Submission - Dartbrook Modification 8 - Time Extension

Having reviewed the likely emissions profile of Mod 8 against NSW's legislated GHG targets, Lock the Gate Alliance **objects** to Dartbrook Modification 8 on climate grounds.

Figure 1: Dartbrook Mod 8's Scope 1 GHGs (blue) vs Scope 1 GHGs if Mod 8 were tracking to Net Zero Dashboard projections - 'abatement as originally designed' (red)

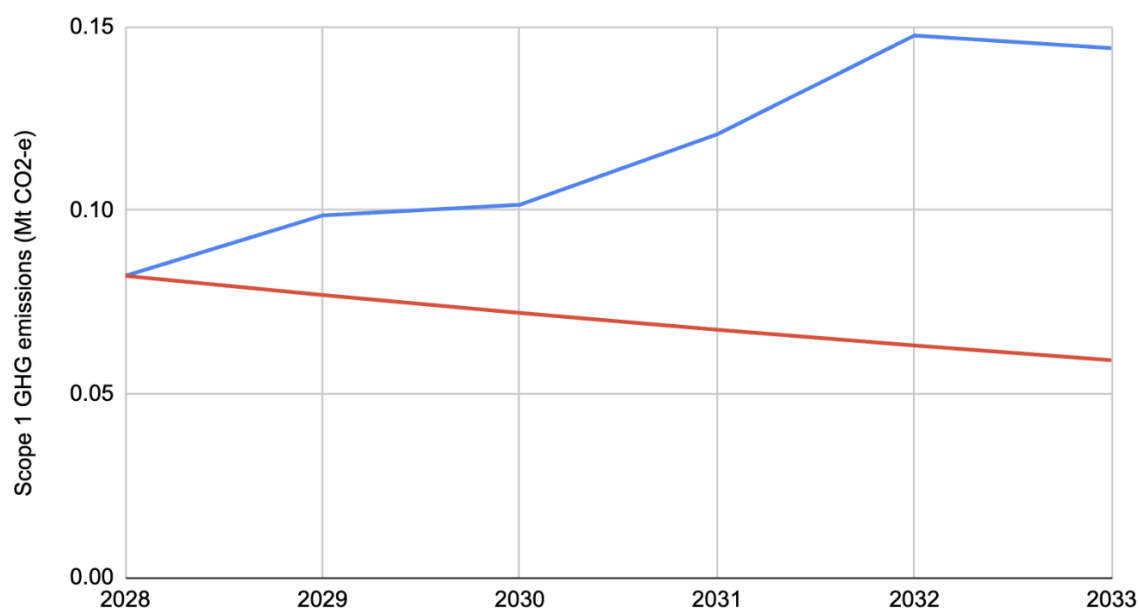
Figure 1 (below) charts total Scope 1 emissions projected by Dartbrook for Mod 8 in blue. The red line represents a Lock the Gate approximation of what a trajectory for Mod 8 might look like if the Project were aligned with NSW DCCEEW's 2024 'abatement as originally designed' scenario. We note that even if a new, high-emitting Project like Dartbrook Mod 8 were aligned with an overall emissions reduction trajectory for NSW (red line), it would still be a burden on the state for the reasons set out in [Lock the Gate's submission](#) to the recent NSW Parliamentary inquiry by the Joint Standing Committee On Net Zero Future into the 2024 Annual Report of the Net Zero Commission.

The Mod 8 Scope 1 emissions trajectory alone is reason enough to refuse consent for this project. As NSW DPHI knows, NSW is not on track to meet legislated targets, including the 2030 target. NSW DCCEEW arrived at this position prior to modelling many additional coal-expansion projects which are currently being assessed by NSW DPHI, including Dartbrook Mod 8. When all of these projects are included in new emissions modelling to be uploaded to the NSW Net Zero Emissions Dashboard in coming weeks, Lock the Gate expects that the emissions gap in 2030 will increase, with Dartbrook Mod 8 emissions a contributing factor.

To state the obvious, the continual increase in Scope 1 emissions proposed for Dartbrook Mod 8 does not represent a meaningful contribution to NSW's emission reduction targets, nor can it be considered action that in any way supports NSW to decarbonise.

Figure 2: NSW Fugitive emissions (coal mining) - 2023 to 2030

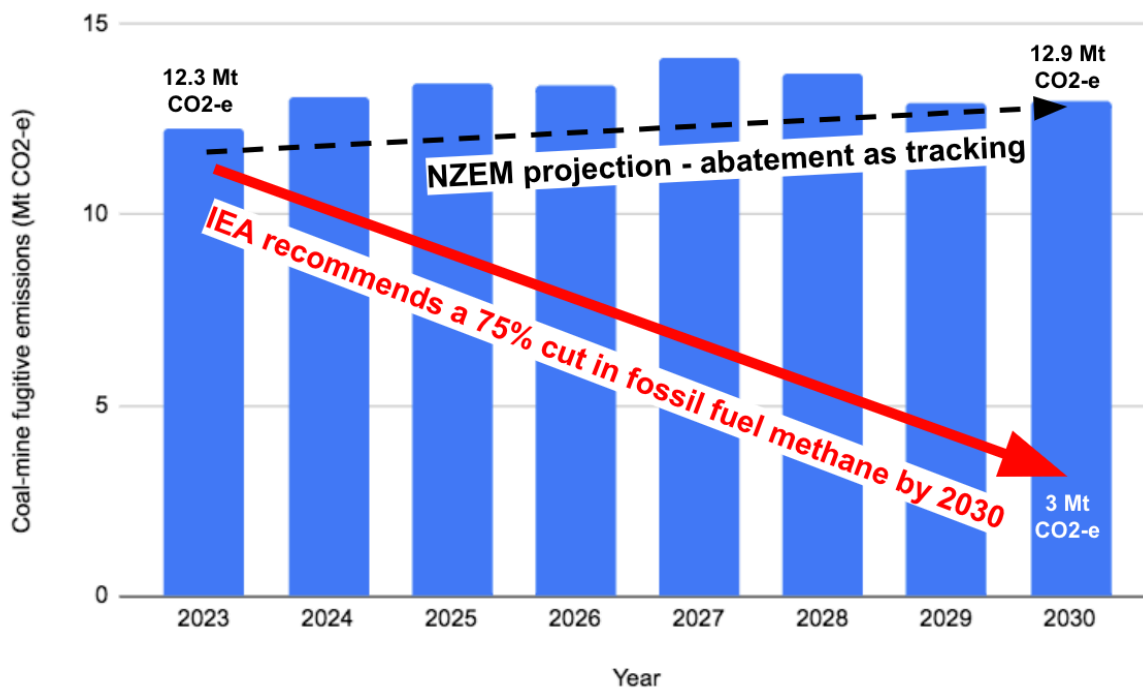
We note that methane emissions from fossil fuels in NSW are projected to increase out to 2030, with Dartbrook’s Mod 8 proposal a contributing factor. As climate scientist Professor Will Steffen used to say, ‘you can’t reduce emissions by increasing them’.
